# Product Change Notification

## 113260 - 01

**Change Notification #:** 113260 - 01  
**Change Title:** Intel® Server System R1304BB4GS9  
PCN113260-01, Product Design  
Update the System Rear Panel and 750W  
Common Redundant Power Supply Firmware  
**Reason for Revision:**  
Add a mylar on the top of the front panel board  
and add a plastic block  
**Date of Publication:** April 13, 2015

Figure 1

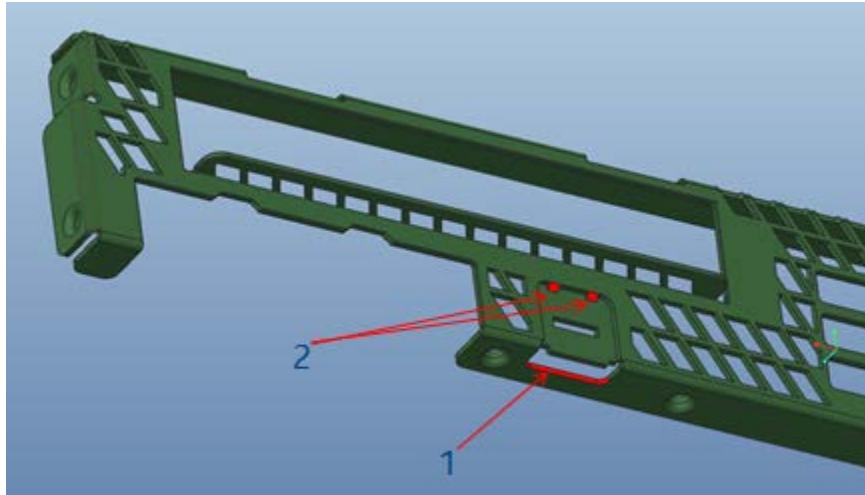
1. Add a connection at the bottom of the RMM4 (Remote Management Module 4) slot to improve structure strength. See item 1 in Figure 1.
2. Update the one big center joint to two smaller joints so that the joints will not conflict with the LAN cable connector latch. See item 2 in Figure 1.

Figure 2

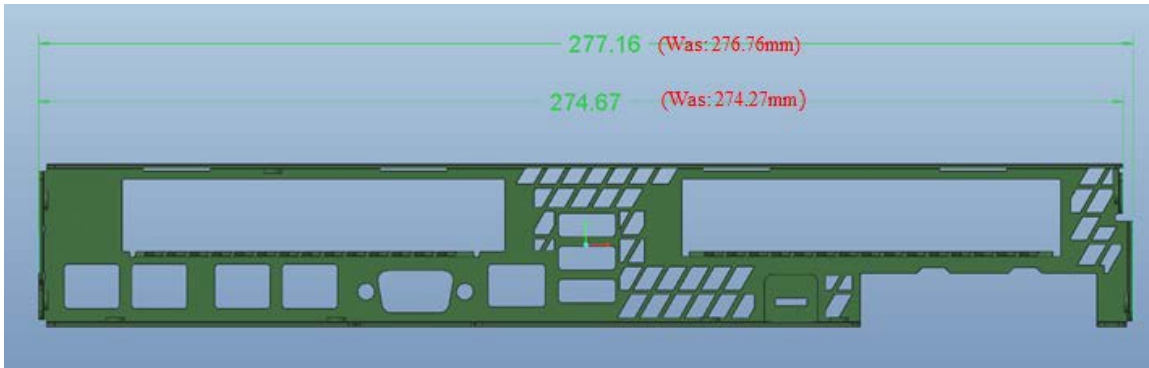
3. Enlarge by 0.2mm at both the left and right sides of the rear panel to improve the flexibility. The previous width was 276.76mm and 274.27mm. The updated width is 277.16mm and 274.67mm. See Figure 2.

Figure 3

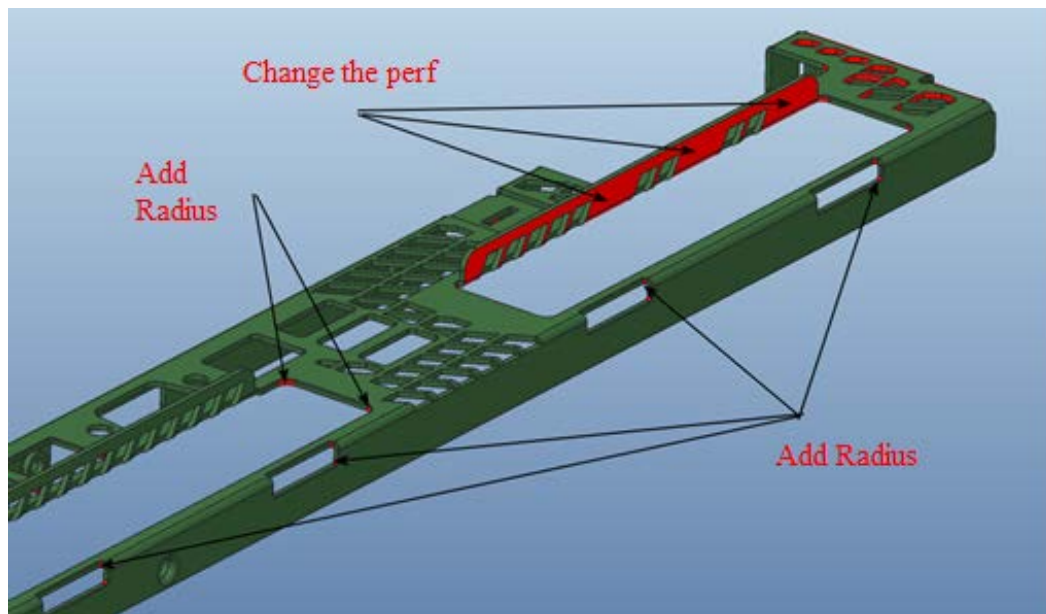
4. Update the perf and add radius to improve structure strength. See Figure 3 and 4.

Figure 5

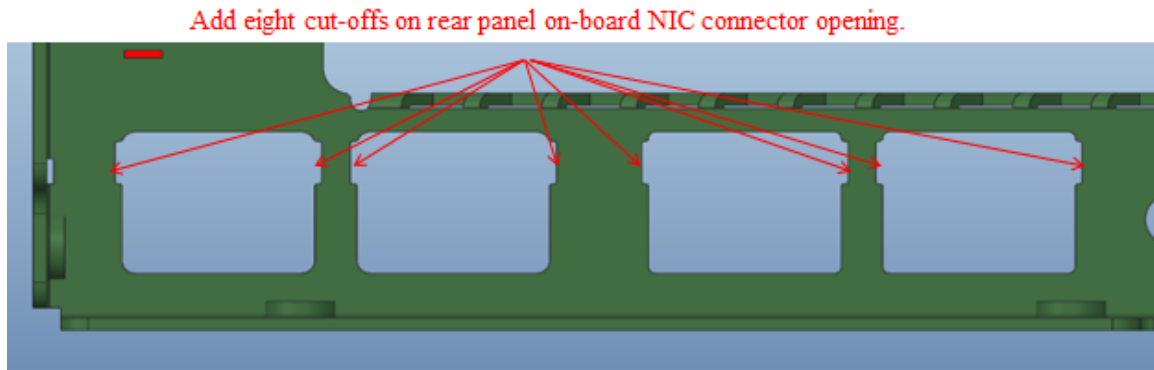
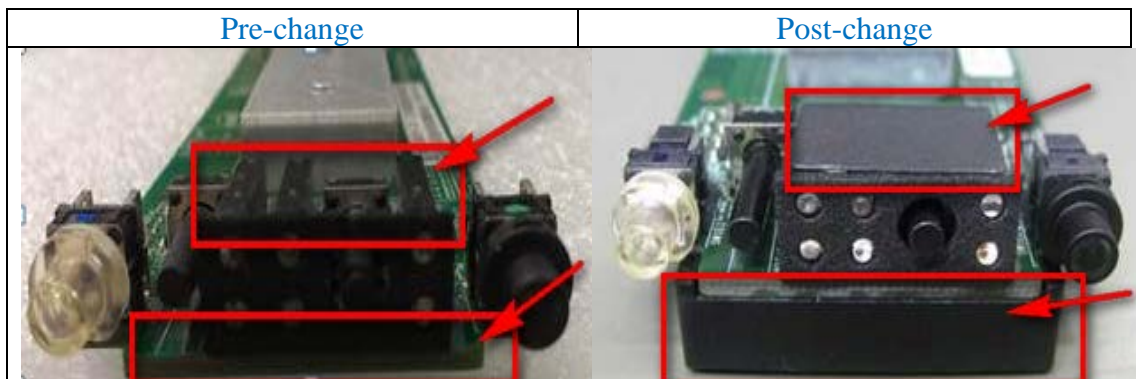
5. Add eight cut-offs around the on-board NIC (Network Interface Controller) openings to improve the LED visibility. See Figure 5.
